DEVIATION REQUEST AND DECISION FORM

Project Name :	Rocky Top Resources
Schedule No.(s) :	6429101029, 6429101030, 6429101031
Legal Description :	TRACT 7 VALLEY GARDENS AS AMD BY ADMINISTRATIVE VAC OF INTERIOR LOT LNS BY REC #206006560 TRACT 1 VALLEY GARDENS, EX THAT PT CONV TO COUNTY BY BK 3823-439 & TO HWY BY BK 5973-205, TOG WITH THAT PT BY VAC RES 04-545, REC #206179579 TRACT 2 VALLEY GARDENS, EX THAT PT CONV TO COUNTY BY BK 3823-439, TOG WITH THAT PT BY VAC RES 04-545, REC #206179579

A deviation from the standards of or in Section 2.3.7.E of the Engineering Criteria Manual (ECM) is requested.

Proposed Turn Lane Design*

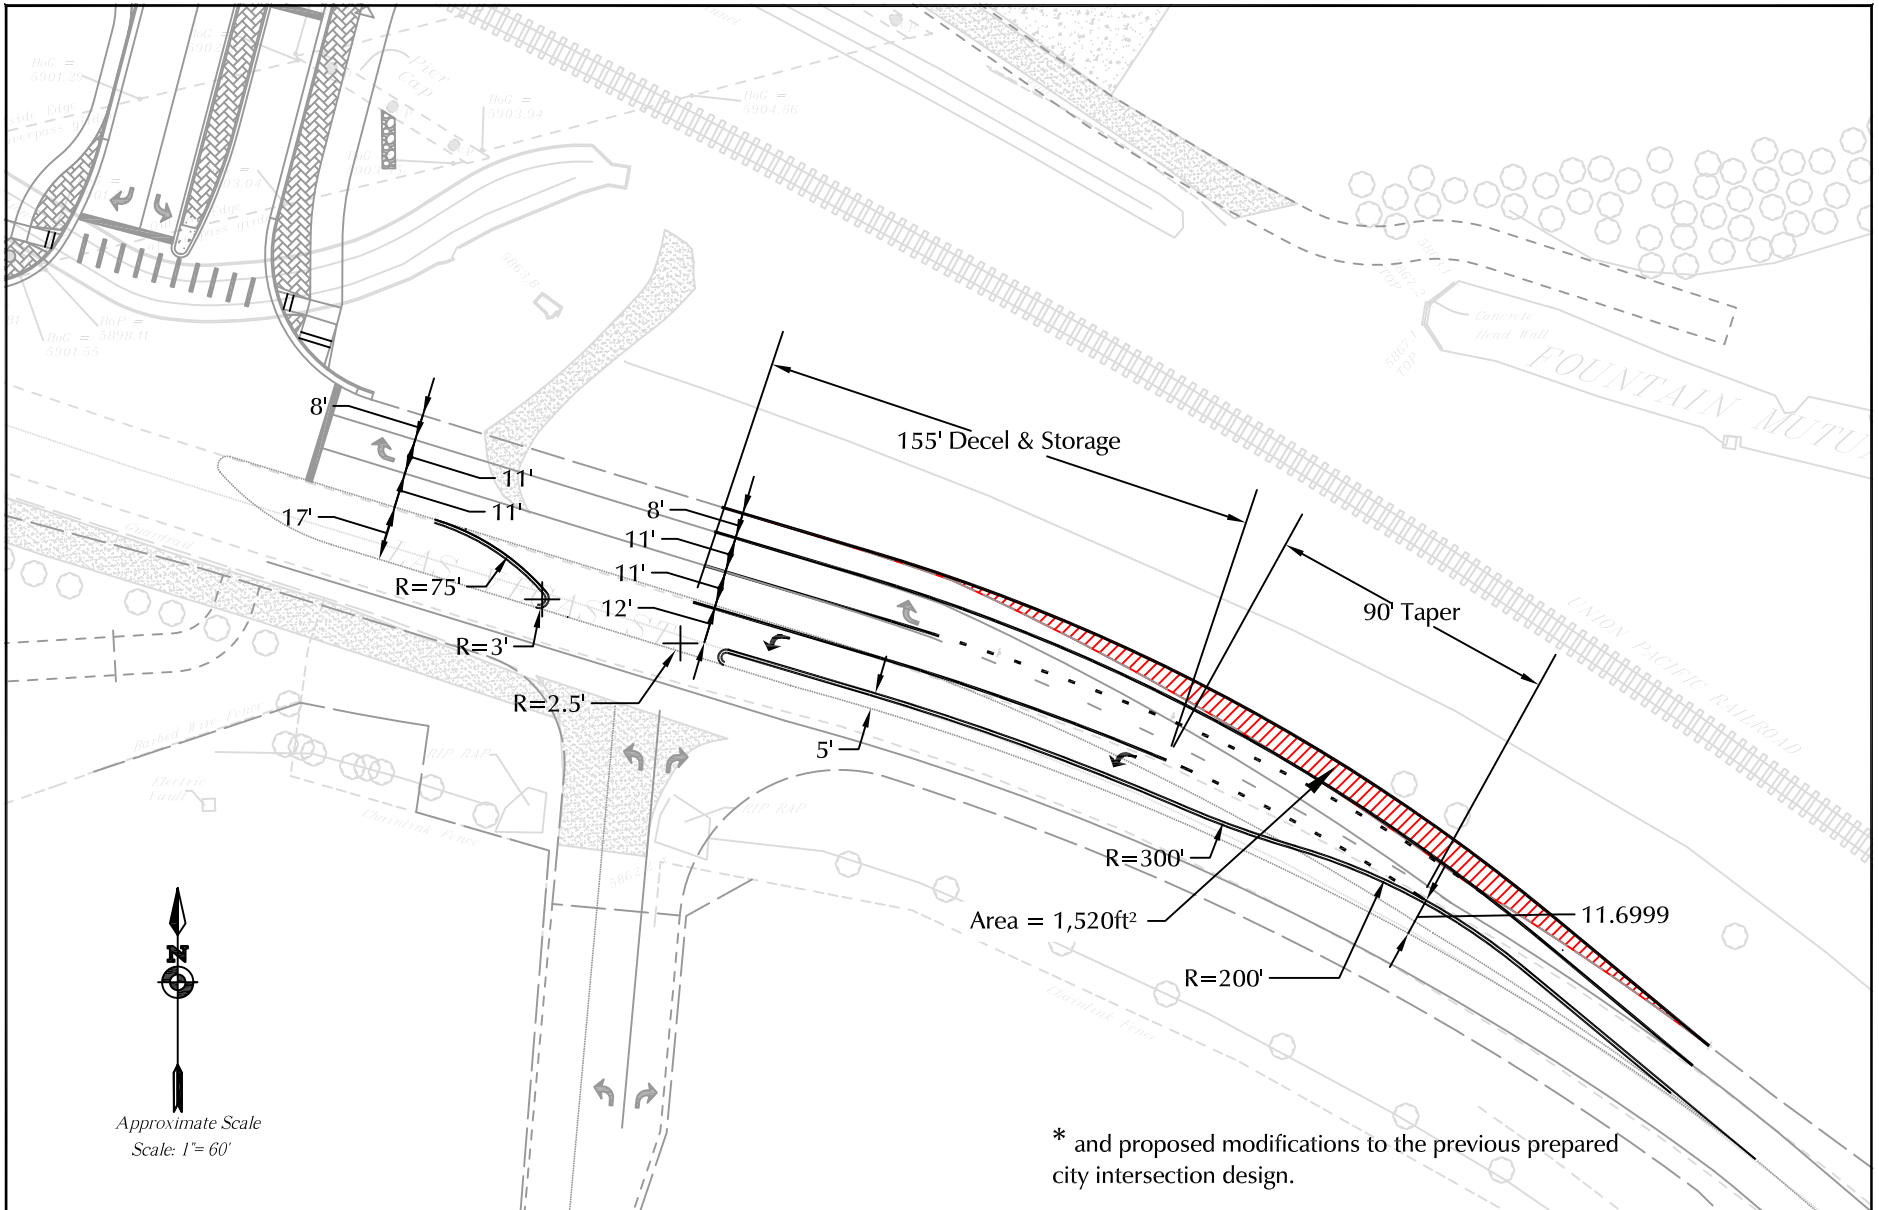
Standard 2.3.7.E (Intersections –Turn Lane Design) requires that the westbound left-turn lane into the site have 50 feet of storage, 195 feet for deceleration, and 180-foot taper. There is an existing two-lane bridge located approximately 500 feet east of the access. Accommodating the full auxiliary lane, taper, (and the required lane redirect taper, which would not be modified) would not be feasible given the distance between the access and the bridge.

The standards require westbound left-turn lane have 50 feet of storage, 195 feet for deceleration, and 180 -foot taper (or 90-foot bay taper). The proposed alternative is 50 feet of storage (meets the standard), 105 feet for deceleration (90 feet short of the standard), and a 90-foot bay taper. Per the ECM "A minimum taper ratio of 8:1 may be used for tangent bay tapers in constrained locations. Bay tapers should be used (asymmetrical reverse curves) for deceleration transition tapers." The 90-foot bay taper would be six feet short of the 8:1 ratio (96'). See attached exhibit.

The bridge to the west of the site limits how far back a lane redirect can begin, which limits the turn lane. The proposed design deviation is not expected to negatively impact safety on the corridor due to the low number of turning vehicles at this intersection. It should be noted that the site is very seasonal and only exceeds the turn lane threshold on Saturdays during peak months (between April and September). Additionally, because the volume of turning vehicles only exceeds the turn lane threshold on Saturdays, the through volume on Las Vegas Street is lower and the 95th percentile queue for the turning movement is less than one vehicle.

The deviation still allows for the standard storage length, 105 feet of the required 195 feet of deceleration distance and a bay taper within 6 feet of a taper length with an 8:1 ratio (which "may be used for tangent bay tapers in constrained locations") storage for the westbound left.

Providing any turn lane for this movement is an improvement over the current roadway layout, which has vehicles making the westbound left-turn from the through lane. The bay taper plus deceleration length is equal to the required deceleration length, so operations and safety should not be adversely impacted. The 150-foot left-turn lane plus bay taper is a typical length in urban areas.

The proposed deceleration lane, although short of the ECM requirements, would maximize the distance possible between the access point and the bridge to the east. The lane would allow for left-turning vehicles to get out of the through lane to complete deceleration (to a potential stop condition) to make the left turn. Following vehicles may need to reduce speed slightly more than if the lane were able to be constructed to the standard length to allow for the initial deceleration of the turning vehicle approaching the access, but this is not uncommon in urban areas and/or areas with constraints to turn-lane length..
